Access Compliance Report

Public Rights-of-Way

Intersection ID: 10020701	Main Street: BEATTIES_FORD_RD	Cross Street: N/A	Location: W
ADA ID: 56B7BA7B812D	Ramp Type: Perp	Initial Pass/Fail: Pass	Overall Compliance: No
			Severity Score: 40

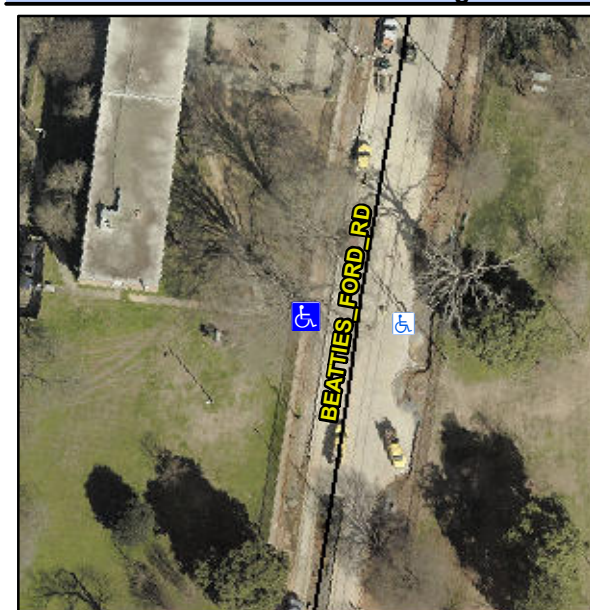
**R304.2.1, R304.2.2-Perp, R304.3.2-
Para, R304.5.3, R305, R302.7.2,
R304.5.4**

Compliance	Description	Data	Compliance	Description	Data
N/A	Ramp Length (in)	76.0	Yes	Ramp Slope (%)	5.8
Yes	Ramp Width (in)	48.0	Yes	Ramp XSlope (%)	0.8
N/A	Flare Type LT	None	N/A	Flare Type RT	N/A
N/A	Flare Slope LT (%)	N/A	N/A	Flare Slope RT (%)	N/A
N/A	Flare Traversable LT?	N/A	N/A	Flare Traversable RT?	N/A
No	Landing Length (in)	N/A	No	DWS Provided?	No
No	Landing Width (in)	N/A	N/A	DWS Contrast?	No
No	Landing Slope (%)	N/A	N/A	DWS Length (in)	N/A
No	Landing X Slope (%)	N/A	N/A	DWS Full Width?	No
N/A	Landing Curb? (Y/N)	No	N/A	DWS Offset (in)	N/A
N/A	Shared Landing?	No			
Yes	Gutter Ponding?	No	No	Gutter Slope (%)	6.4
No	Gutter Lip Ht (in)	1.5	Yes	Gutter X Slope (%)	1.3
N/A	Painted X Walk1?	No	N/A	Painted X Walk2?	N/A
	X Walk 1 Direction	To E		X Walk 2 Direction	N/A
N/A	X Walk 1 Width (in)	N/A	N/A	X Walk 2 Width (in)	N/A
	X Walk 1 Slope (%)	6.7		X Walk 2 Slope (%)	N/A
	X Walk 1 X Slope (%)	1.7		X Walk 2 X Slope (%)	N/A

**Remove & Replace Entire Ramp.
Remove & Replace Gutter.**
